Product Notice

Austdac UPS (UPS12NMH288-1000-A)

Photo 1 UPS Types

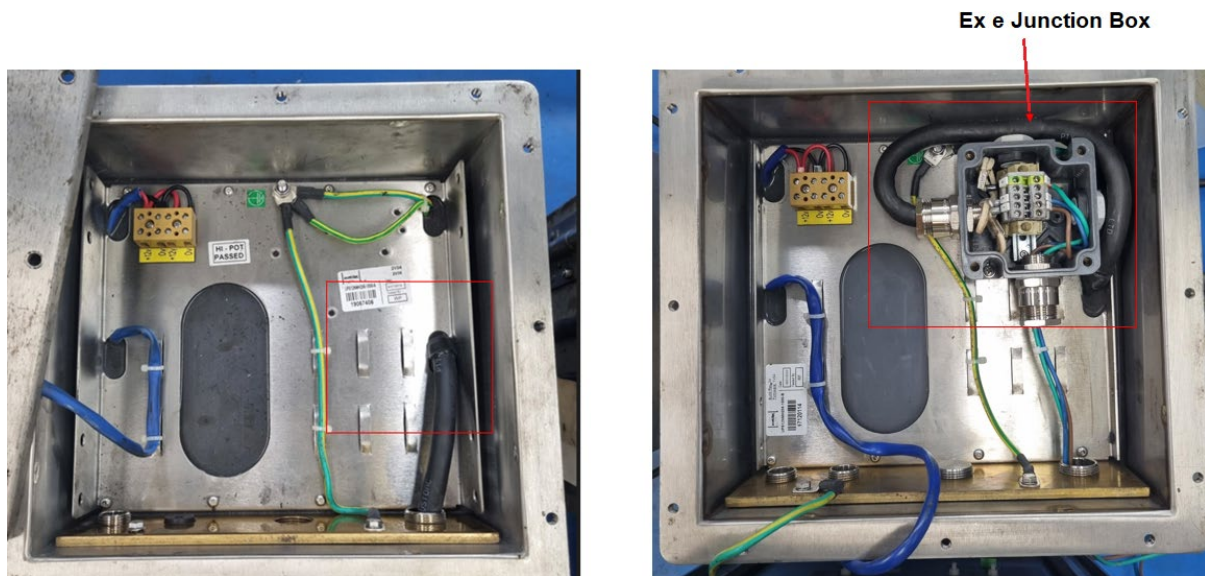
The UPS12NMH288-1000-A (A version) has an integrated 10m Type 2S mains cable. The user usually cuts this cable to length and connects the cable to the mains in a user supplied Ex junction box. When the UPS is returned for service, repair or overhaul it is Austdac's normal practise to replace the integrated Type 2S cable. The integrated Type 2S cable is potted and replacement of the cable requires the potting to be removed with the potential for damage to the UPS.

The UPS12NMH288-1000-B (B version) has an Ex e terminal box inside the UPS for the user to easily connect and disconnect from the mains once the unit has been isolated.

Austdac will be phasing out the UPS12NMH288-1000-A (A version) and recommend all users use the UPS12NMH288-1000-B (B version). This will allow the user to connect and disconnect the UPS easier and reduce service, repair and overhaul costs as the integrated cable will not need to be replaced.

Austdac also recommend that existing UPS12NMH288-1000-A (A version) returned for service, repair or overhaul be converted to a B version.

All future UPS12NMH288-1000-B (B version) will be supplied with a 10m Type 2S cable.
